# Conceptual Review Agenda

# Aggie Village North Redevelopment

**Re:** Aggie Village North Redevelopment

**Description of project:** This is a request to redevelop the existing Aggie Village North site located on CSU-owned land at approximately 500 West Prospect Road (Parcel #s 97144-08-033, 97144-08-912 & 97144-15-901). Existing structures would be deconstructed and redeveloped with new student apartment housing, flex spaces, retail space and pedestrian amenities. The project is subject to the Site Plan Advisory Review (SPAR) process which goes before the Planning & Zoning Board.

Section A-A'

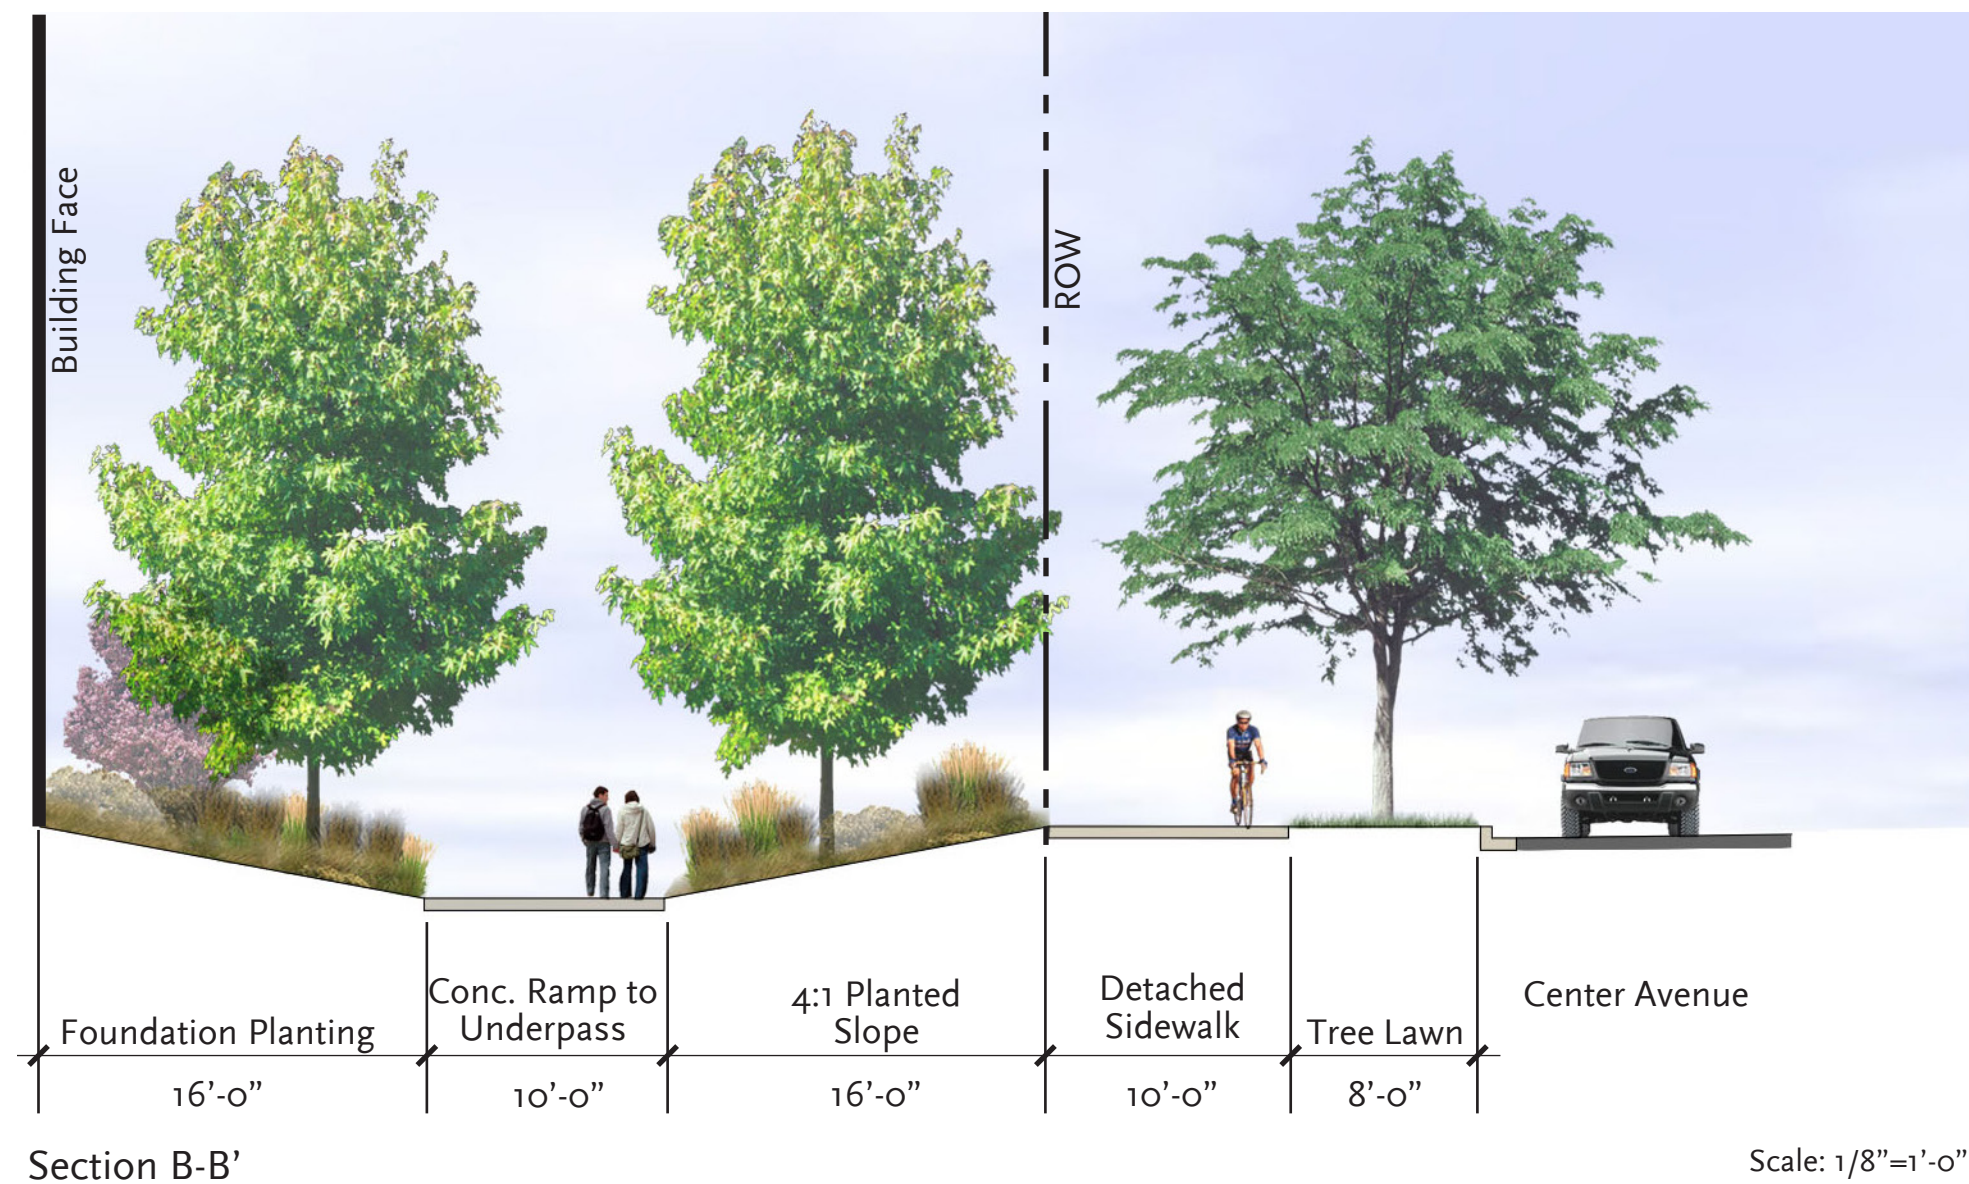
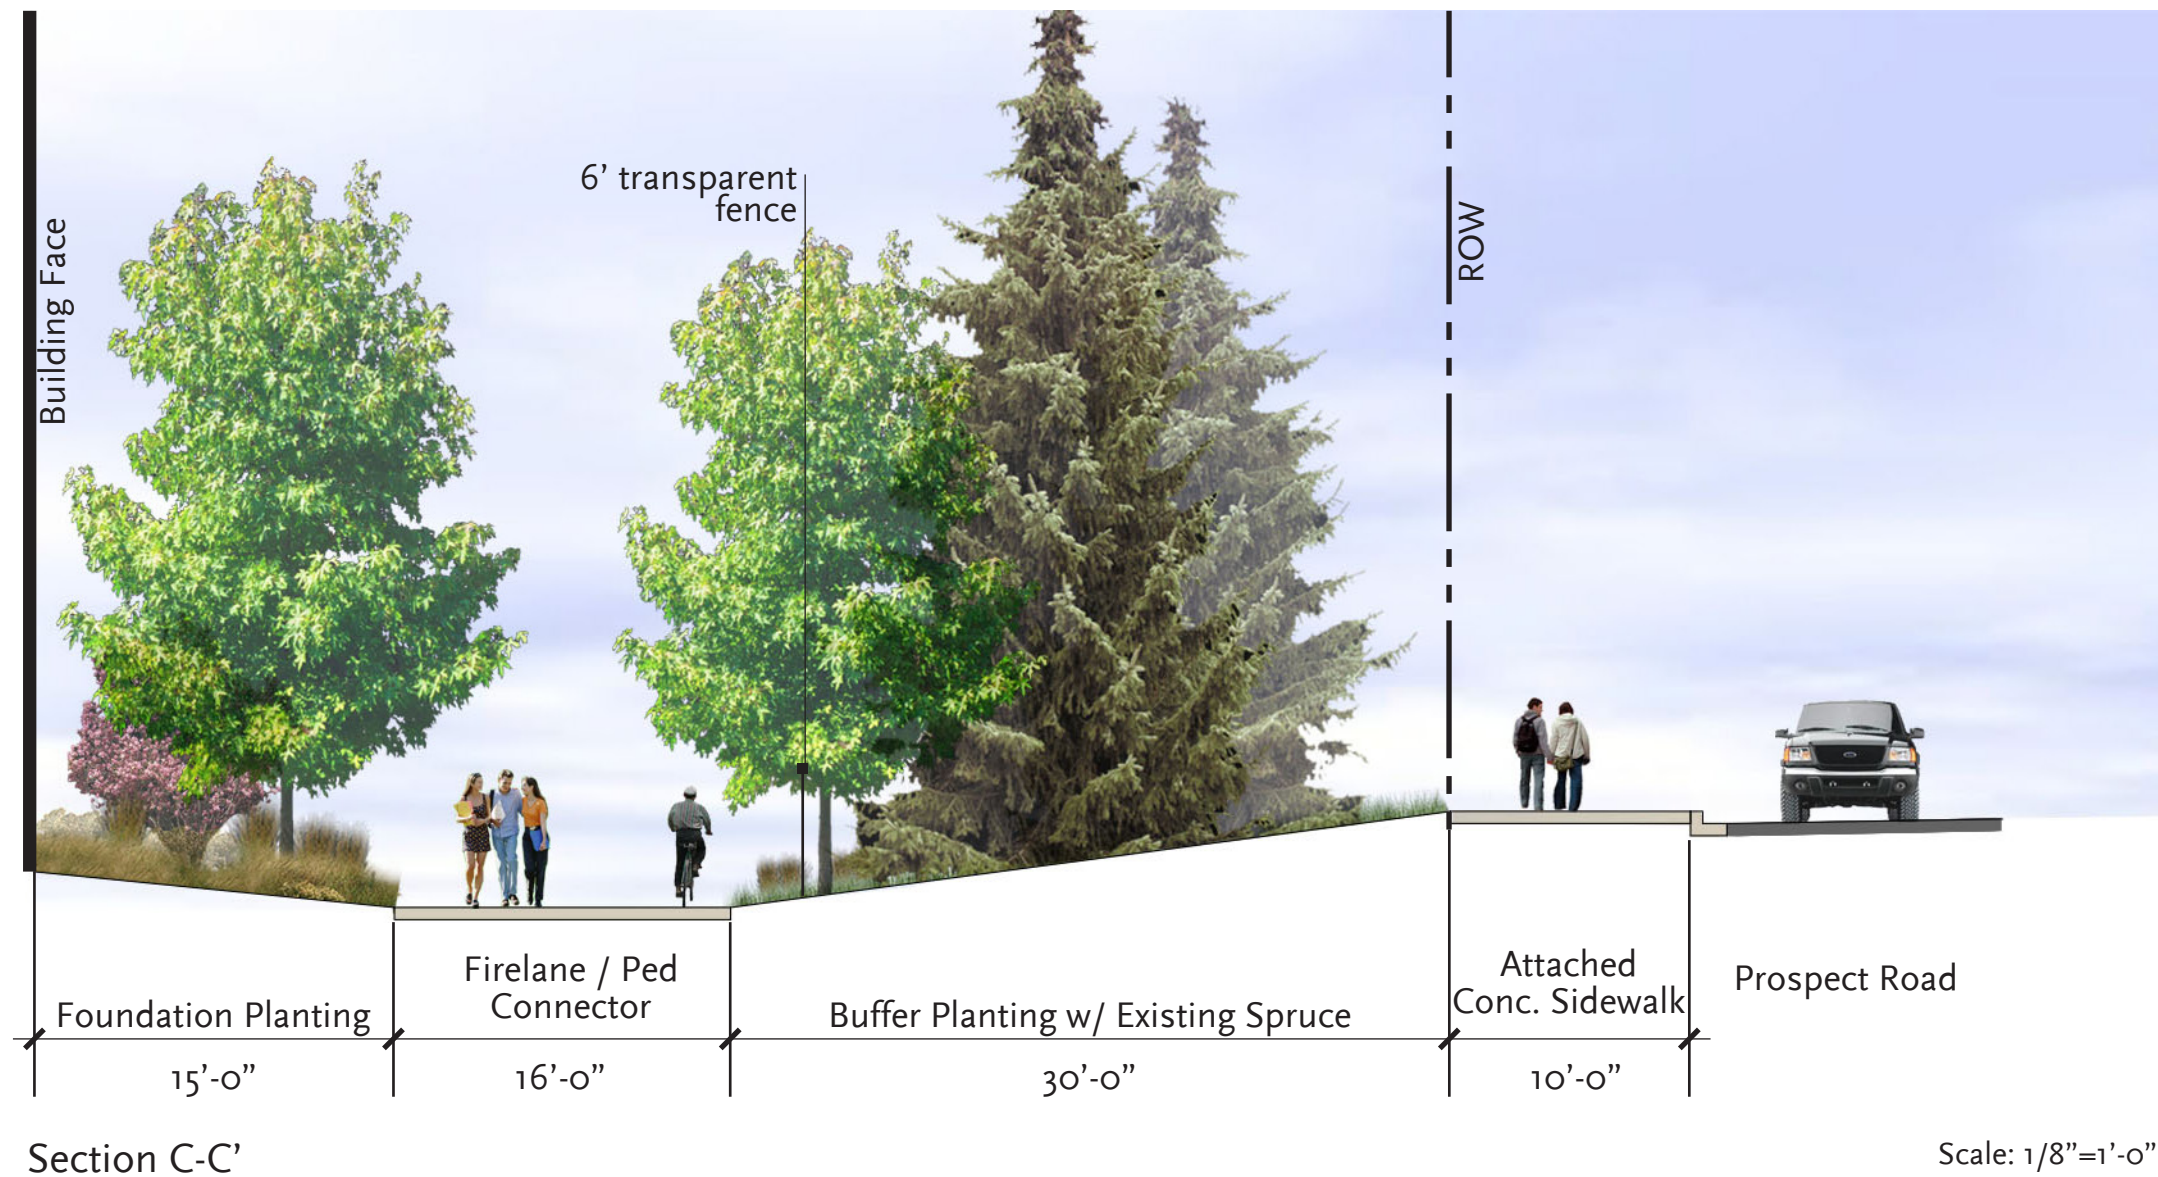
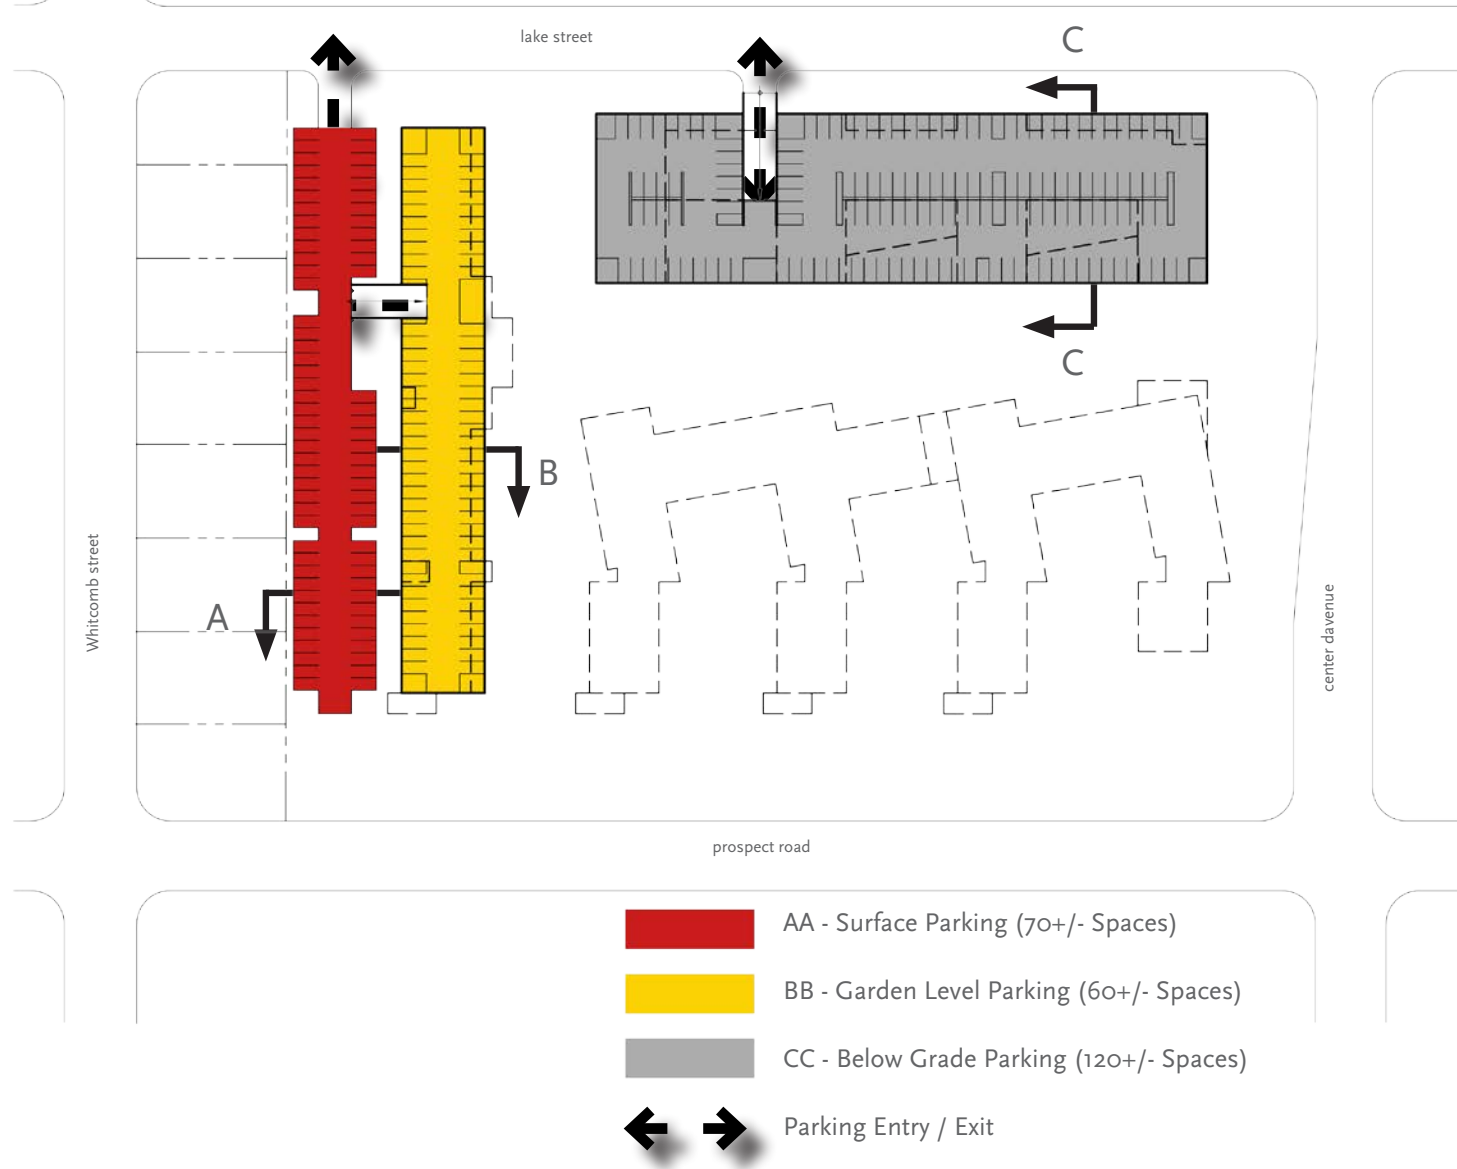
8. The proposed Prospect road section identifies a 10ft attached sidewalk. Our current minimum street standards for Prospect Road (classified as a 4 lane Arterial Street) will require a detached 6ft wide sidewalk and a 10ft wide landscaped parkway with street trees. The proposed 16ft pedestrian connector that runs along Prospect can serve as the detached sidewalk requirement but will need to connections to the existing public sidewalk at the east and west property boundaries

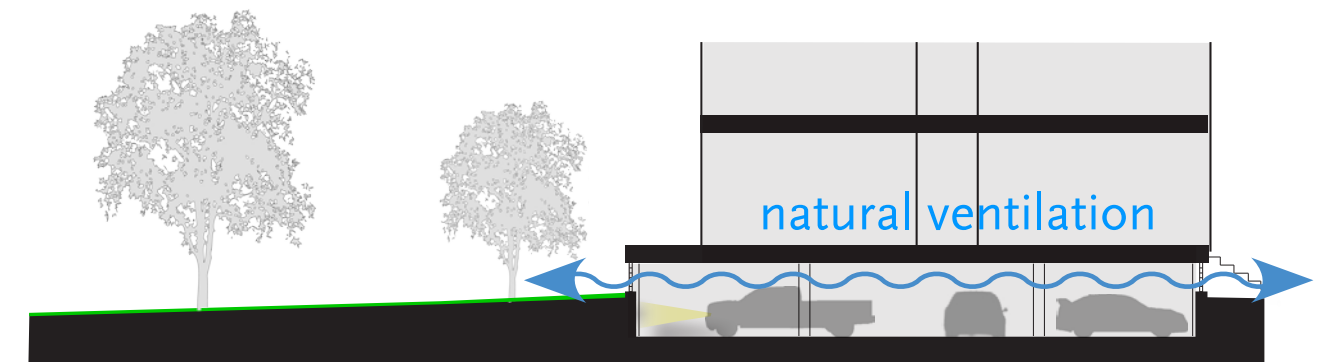
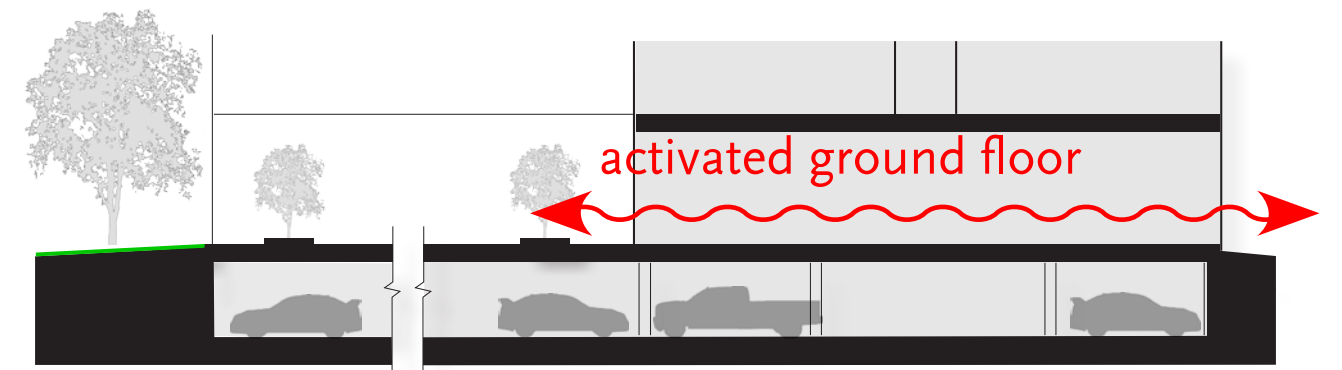
While the PFA does not control the amount of parking spaces to be provided, we ask the applicant to seriously consider the consequences of providing for only a 25% parking stall to resident ratio. PFA is

currently attempting to mitigate overflow parking concerns at other sites. Overflow parking often results in the blockage of critical emergency access while also creating an ongoing burden for enforcement officials.

2. In order to evaluate potential parking impacts, additional parking demand information is being requested of the applicant. Staff requests documentation demonstrating the demand for existing parking at Aggie Village, and projected parking demand of the proposed project, based upon a summary of the residential population demographics, i.e.-international students, married students, graduate/postdoc/scholar community and unaffiliated undergraduate students, and their respective household sizes, vehicle ownership and use.
